SPECIAL USE EXCEPTION REVIEW REPORT

Petition Number: SUE 20-05

Project Name: ELCO Cadillac
Special Use Exception Site Development Plan Amendment
Amending Site Development Plan for New Showroom Footprint

SITE PLAN	
SHEET TITLE	SITE PLAN
JOB NUMBER:	3412
DRAWN BY:	BDN
DATE:	5/13/20
CHECKED BY:	JLW
DATE:	5/13/20
SHEET:	C3.0

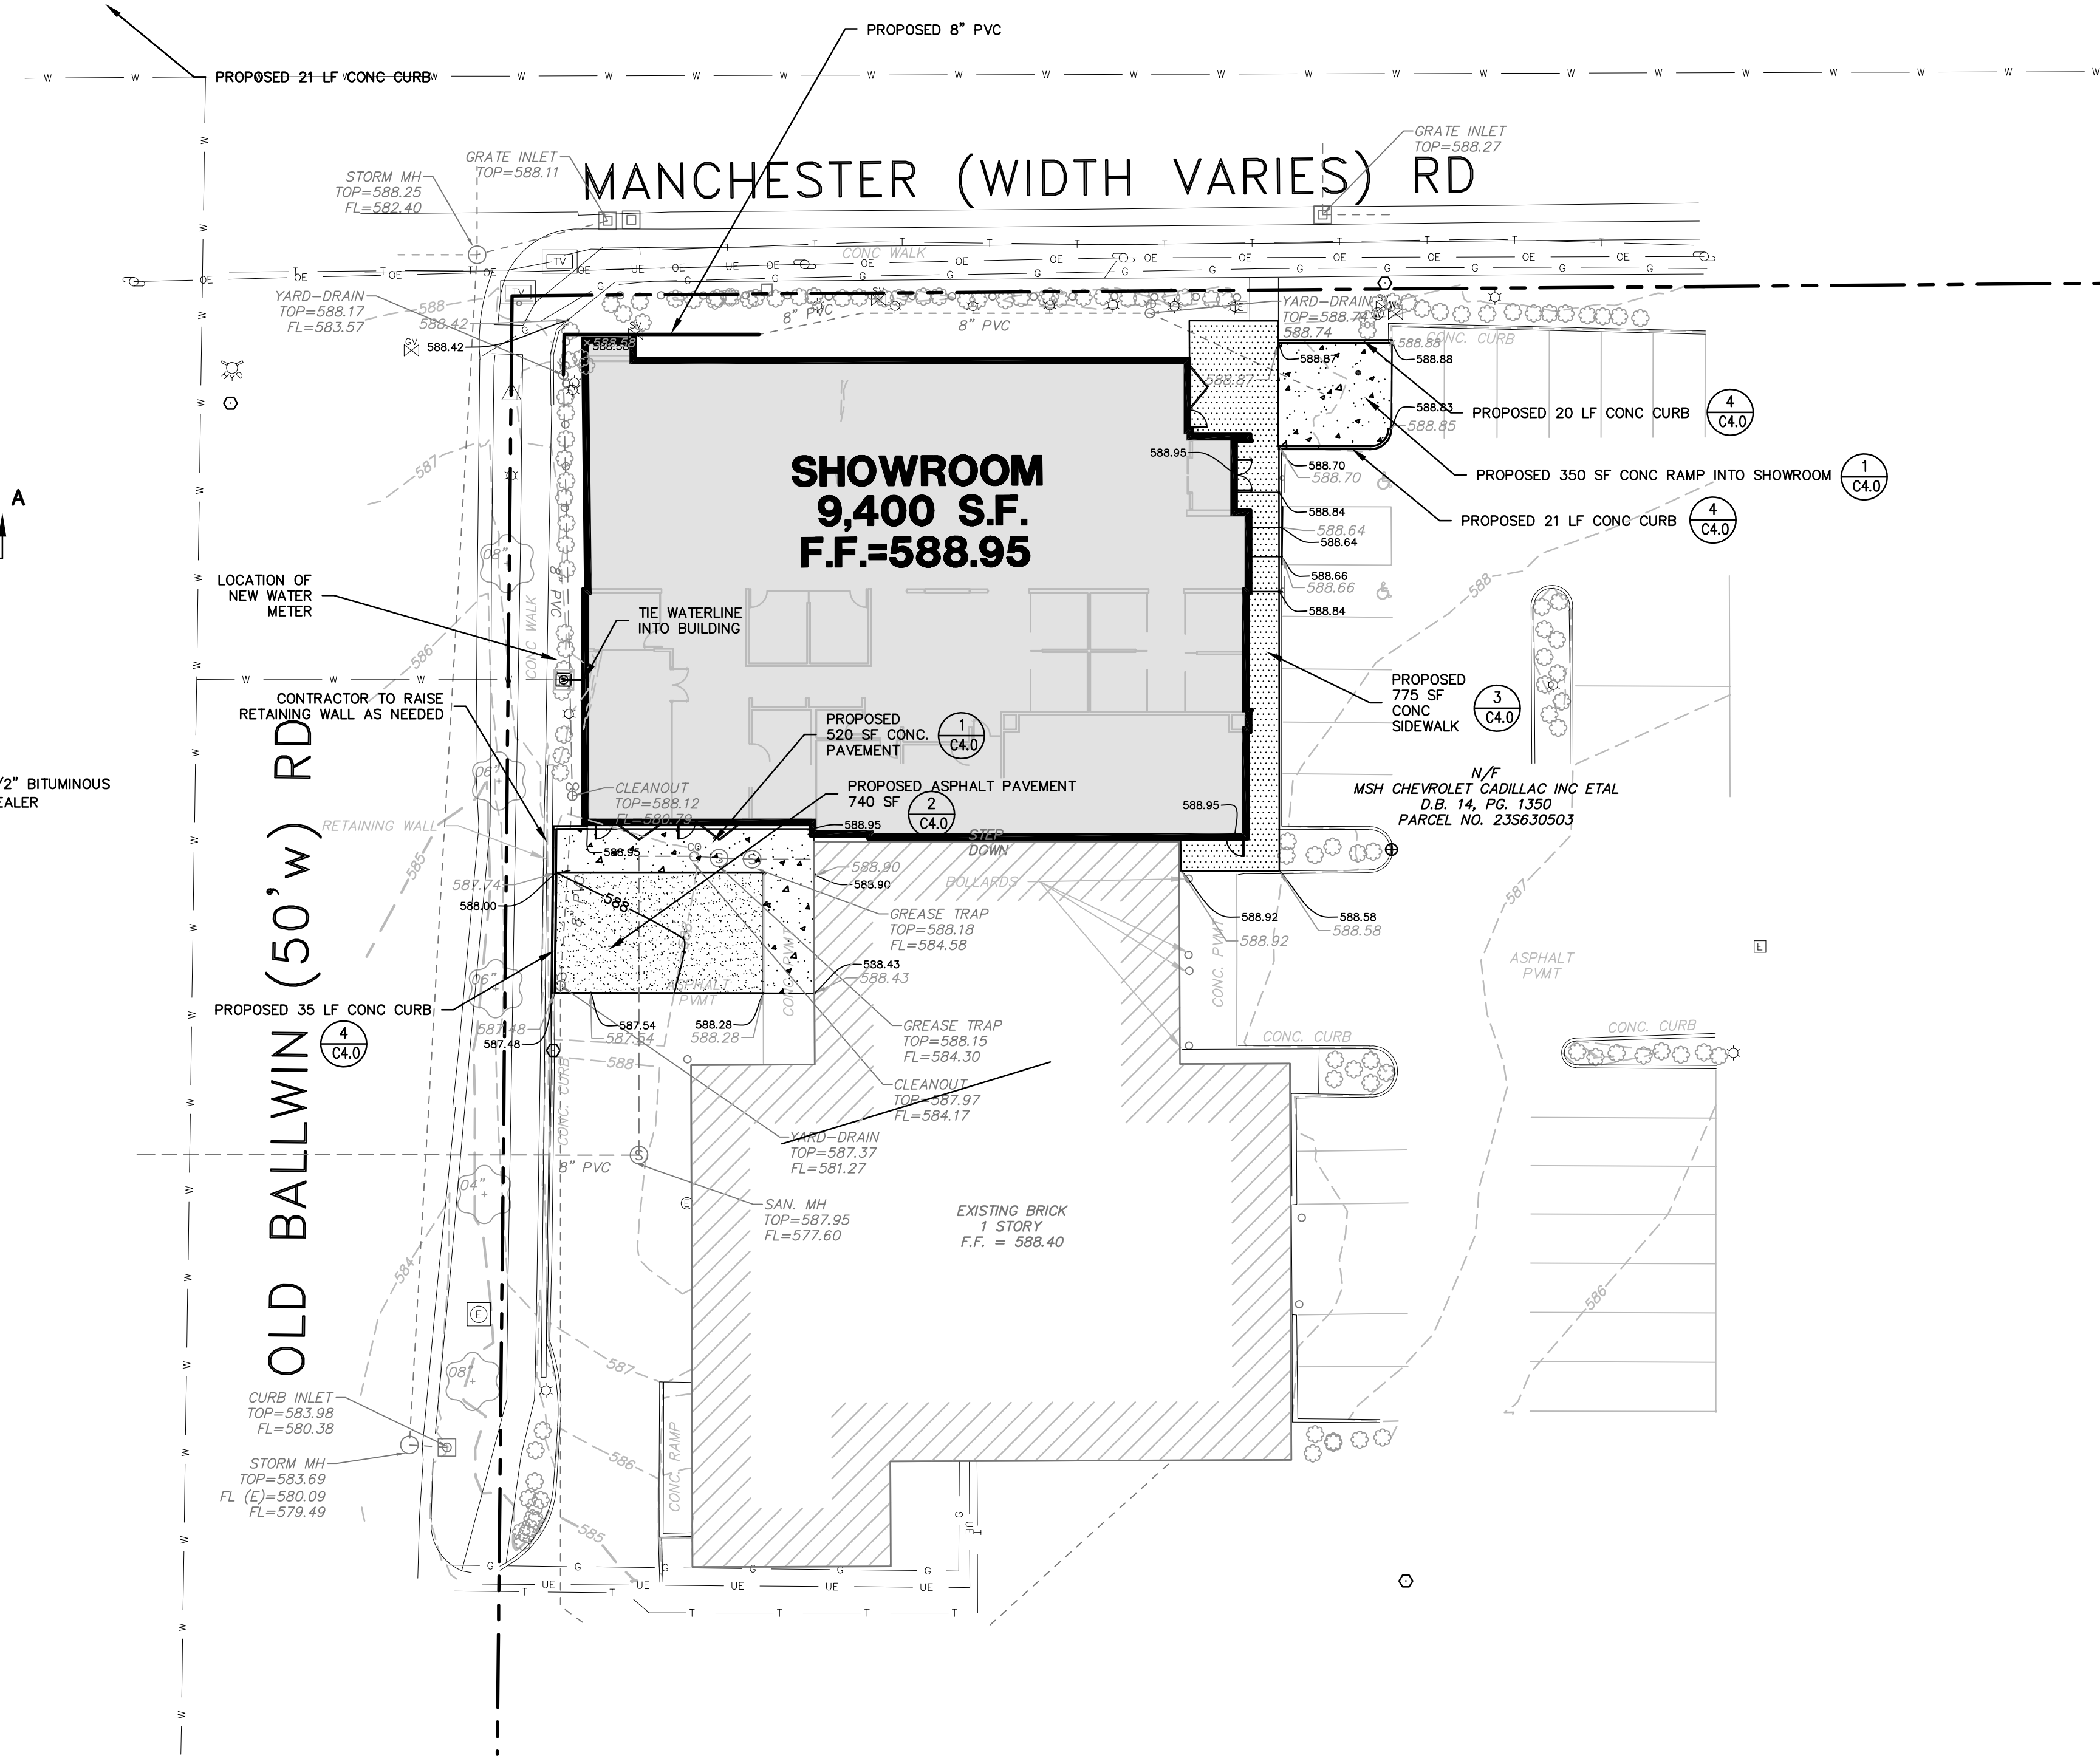
- Art. XIIC, Sec. 7(2) requires sidewalk width of six feet along all sides of a lot that abuts public or private right-of-way. This proposal does not deviate from the previously approved site development plan. This location's principal customer entrance occurs next to a parking area.

- Art. XIIC, Sec. 7 (3) subsection requires that sidewalks be provided along any building façade abutting a parking area or a roadway and such sidewalks shall be at least 12' wide. This subsection goes on to say that these extra wide sidewalks are required to provide room for sidewalk sales, eating, etc. The amended site development plan fails to provide a width for the sidewalk, only stating that the width "varies." I have brought this to Mr. Elli's attention. An amended plan has not been brought forward for evaluation as of the 7/22 final deadline.

I spoke with the location's architect, Tim Elli, on 7/13/2020, voicing concern regarding the fact that the proposal removes the front plaza and infringes on the extra-wide sidewalk on the current building's eastern side, he stated that he would look into these items of concern and attempt to bring forward an updated site development plan before the August P&Z Meeting deadline. While it is the Commission's evaluation of the design aspects for this site that will ultimately provide approval, I do have concern toward the removal of the previously approved plaza space in front of the current showroom in favor of an overly uniform forward-facing façade that may be detrimental to any future attempt for walkability along the Manchester Corridor.
